# Access Compliance Report

## Public Rights-of-Way

### (Curb Ramps)

Intersection ID: 13891	Main Street: CLEMENT_AV	Cross Street: E_7TH_ST	Location: E
ADA ID: 00D17612E320	Ramp Type: PerpDiag	Initial Pass/Fail: Fail	Overall Compliance: No
Severity Score: 12.5			
Codes/Mitigation Info/Possible Solution		Field Measurements/Component Compliance

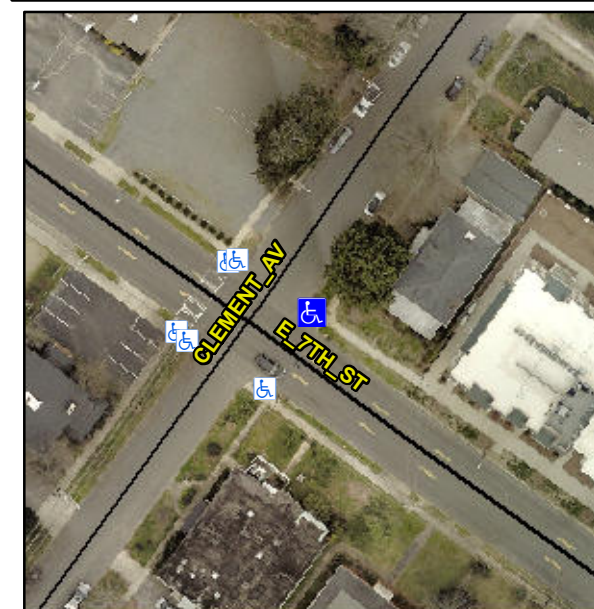
**Not Found, R304.2.2**

Compliance	Description	Data	Compliance	Description	Data
N/A	Ramp Length (in)	75.0	No	Ramp Slope (%)	9.8
Yes	Ramp Width (in)	60.0	Yes	Ramp XSlope (%)	0.4
N/A	Flare Type LT	N/A	N/A	Flare Type RT	N/A
N/A	Flare Slope LT (%)	N/A	N/A	Flare Slope RT (%)	N/A
N/A	Flare Traversable LT?	N/A	N/A	Flare Traversable RT?	N/A
N/A	Landing Length (in)	N/A	N/A	DWS Provided?	N/A
N/A	Landing Width (in)	N/A	N/A	DWS Contrast?	N/A
N/A	Landing Slope (%)	N/A	N/A	DWS Length (in)	N/A
N/A	Landing X Slope (%)	N/A	N/A	DWS Full Width?	N/A
N/A	Landing Curb? (Y/N)	N/A	N/A	DWS Offset (in)	N/A
N/A	Shared Landing?	N/A			
N/A	Gutter Ponding?	N/A	N/A	Gutter Slope (%)	N/A
N/A	Gutter Lip Ht (in)	N/A	N/A	Gutter X Slope (%)	N/A
N/A	Painted X Walk1?	No	N/A	Painted X Walk2?	No
	X Walk 1 Direction	To NW		X Walk 2 Direction	To SW
N/A	X Walk 1 Width (in)	N/A	N/A	X Walk 2 Width (in)	N/A
	X Walk 1 Slope (%)	0.4		X Walk 2 Slope (%)	1.3
	X Walk 1 X Slope (%)	1.4		X Walk 2 X Slope (%)	1.5

**Remove & Replace Curb Ramp With Two New Directional Ramps or Equivalent.**
